Subject: CLACKING NOISE WHEN STARTING TO MOVE VEHICLE WHILE STEERING WHEEL IS TURNED TO FULL LEFT POSITION	Bulletin No: 06-002/13
	Last Issued: 10/09/2013

2013-2014 CX-5 vehicles with VINs lower than JM3KE*****369145 (produced July 3, 2013)

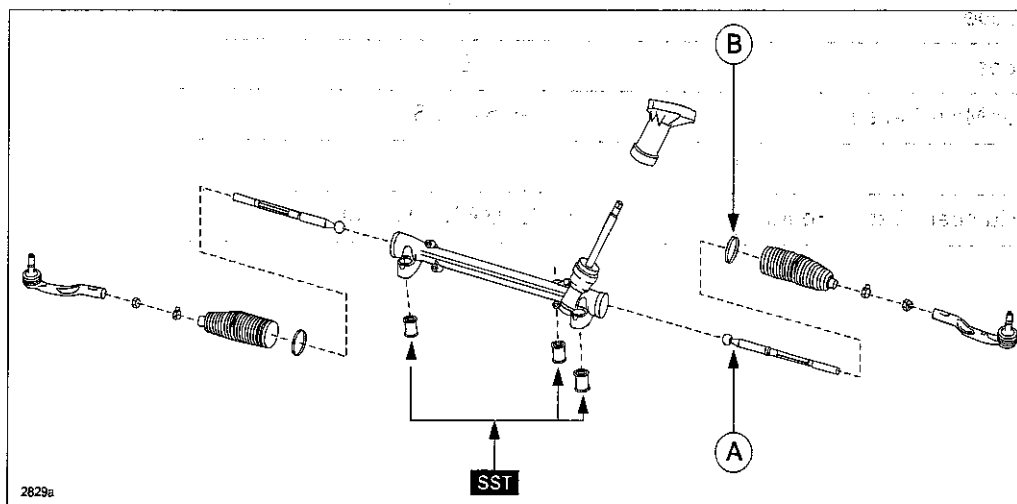
The noise is caused when the edge of the left side inner ball joint (A) gets stuck with the steering gear housing. The shape of the inner ball joint edge has been changed to eliminate this noise.

NOTE: Be sure to replace wire clamp (B), the joint bolt and both snap pins.

1. Verify the customer concern by turning the steering wheel full left, then start moving the vehicle.
2. Remove the steering gear and linkage according to the on-line instructions on MS3 or the Workshop Manual (section 06-13 STEERING GEAR AND LINKAGE REMOVAL) and replace the left inner ball joint (section 06-13 STEERING GEAR AND LINKAGE DISASSEMBLY).
